**From:** Garril Page <obility@comcast.net>  
**Sent:** Monday, August 11, 2025 10:48 AM  
**To:** Julie McMillan; Elizabeth Robbins; Teri Dowling; msalter@gmail.com; Bill Kircher  
**Cc:** Christa Johnson; Cyndie Martel  
**Subject:** [EXTERNAL] ITEM 12 Ross Council Meeting Aug 14, 2025  
**Attachments:** BB2 Strain gauges May 2025.pdf; Creek Park report.pdf

### Comment on MT-2 Application

**RE: Creek Park redwoods, San Anselmo**

## ARBORIST REPORT

## Gauge 1

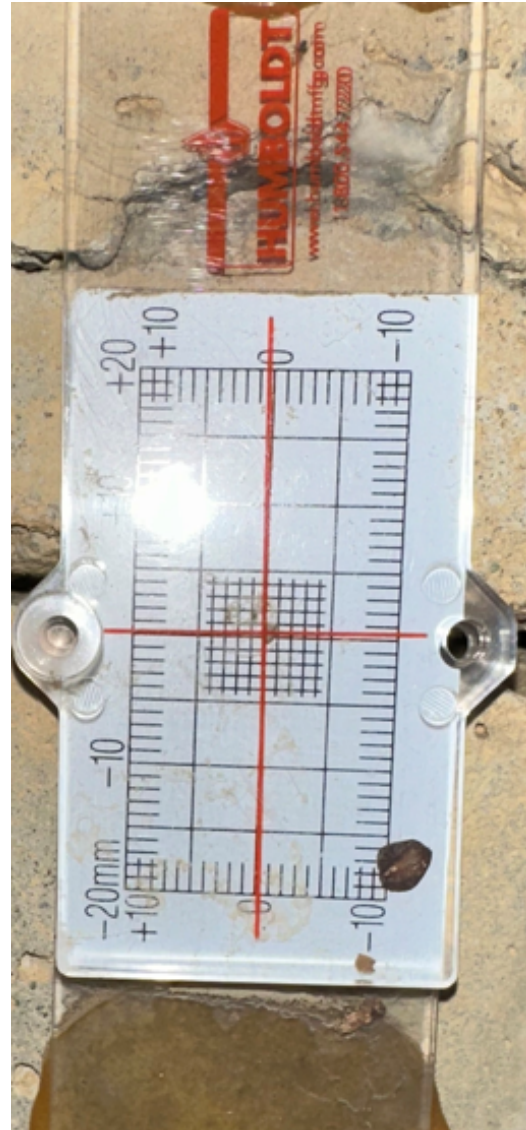
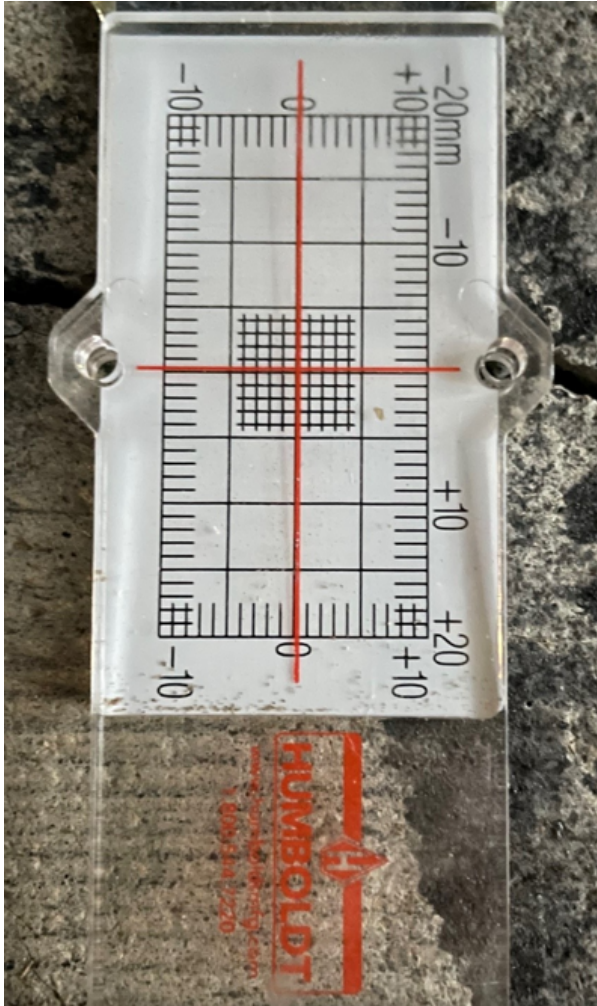
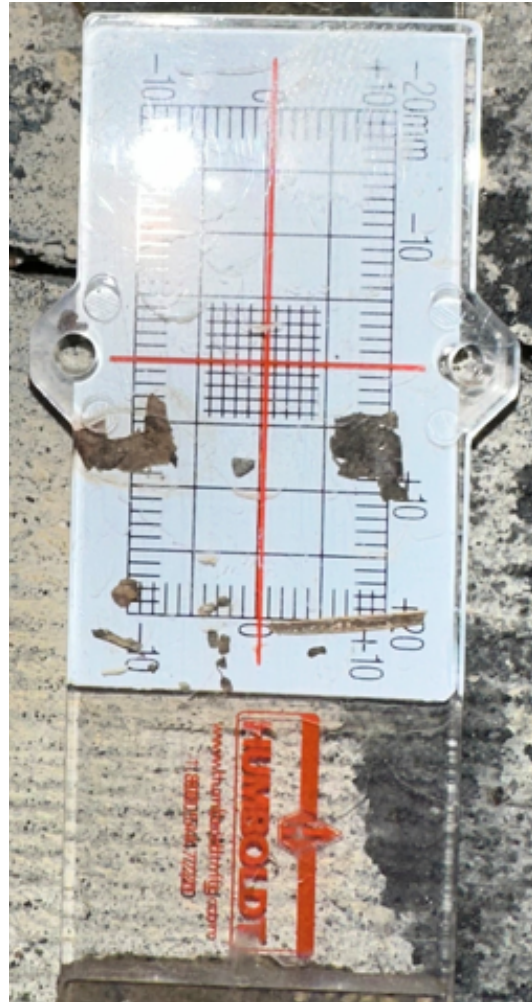
Nowhere is the reader informed that there are years of strain gauge reading conducted by San Anselmo DPW that show BB2 to be structurally stable. (see below) Questions regarding reuse of the plaza have been ignored while the District repeats debunked claims and the spite fence continues to blight the heart of downtown San Anselmo.

Tree Protection Zones for 13 redwoods that are likely to become unsafe and require removal unless plans are modified and tree protection is implemented, per industry standards.

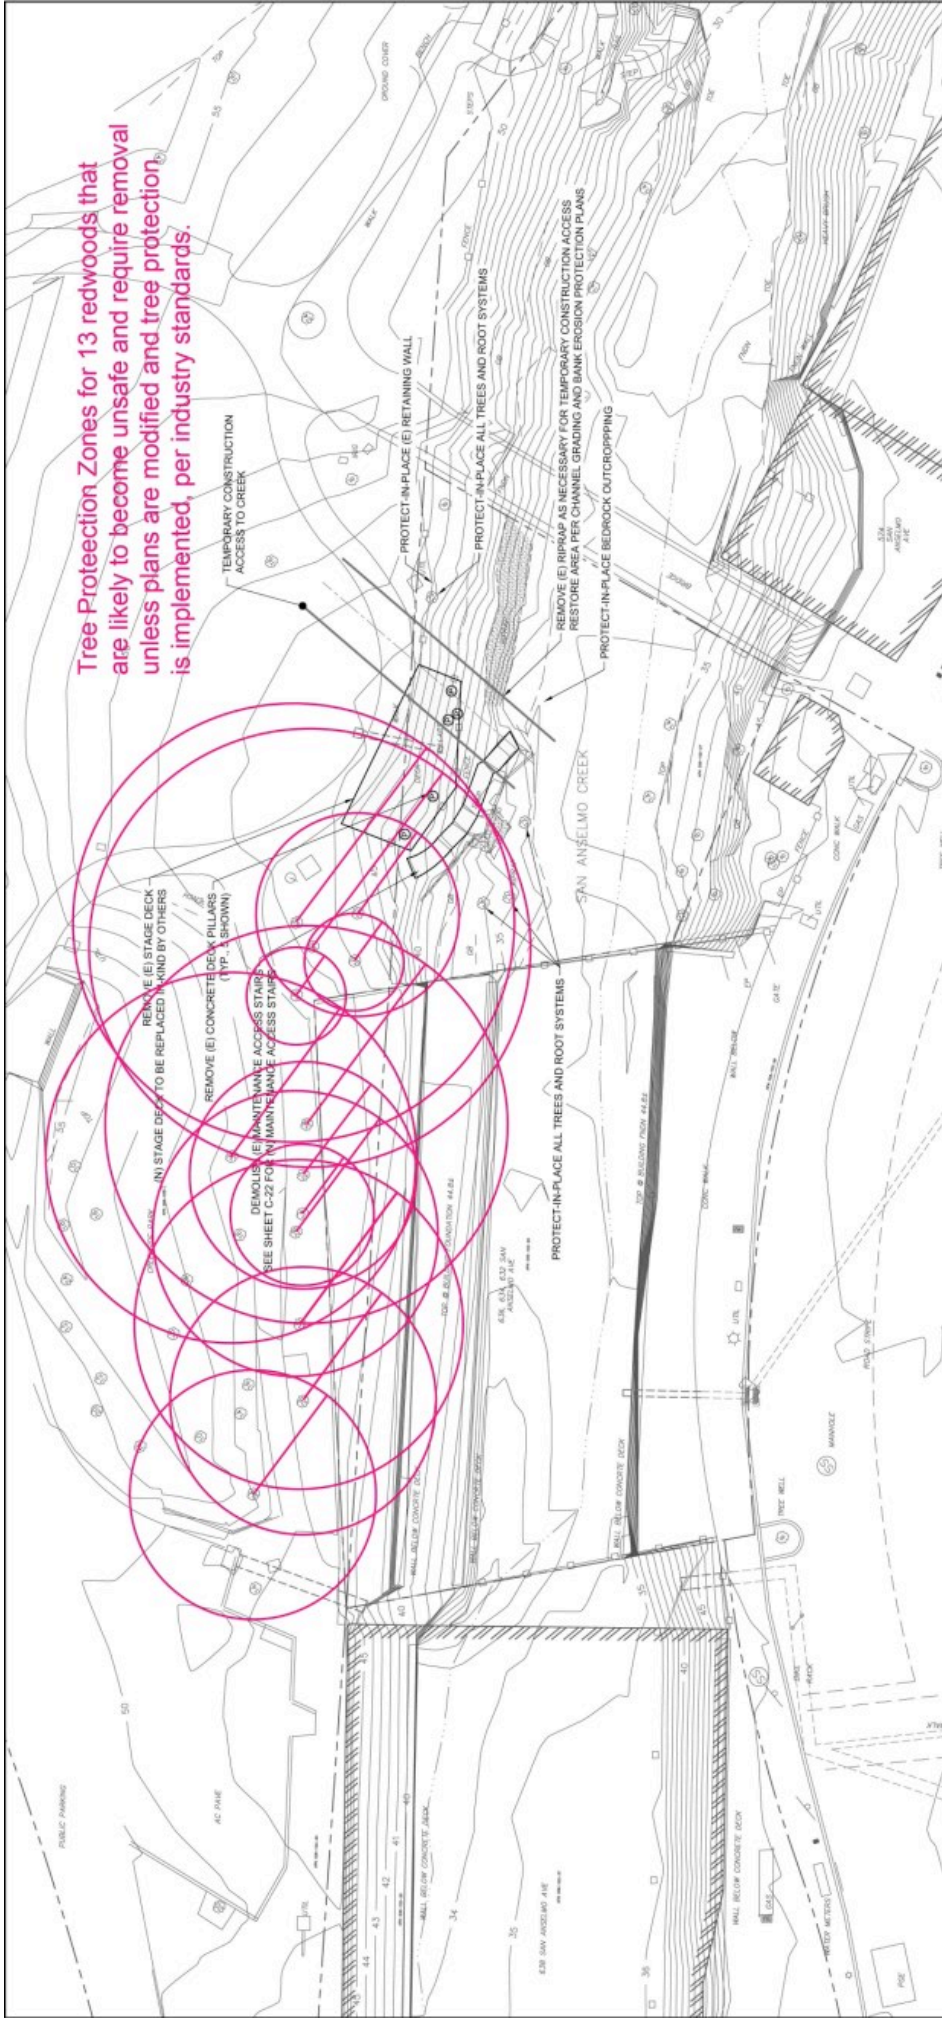
The attached photographs are of the site and the redwood trees that will require removal based on the design. Sheet G-7 by Stetson Engineers identifies tree locations and trunk diameters, and the attached markup shows tree protection zones for these 13 redwood trees.

The tree protection zone (TPZ) diameter is 20 times the trunk diameter. All trees are good candidates for preservation based on their pre-construction condition.
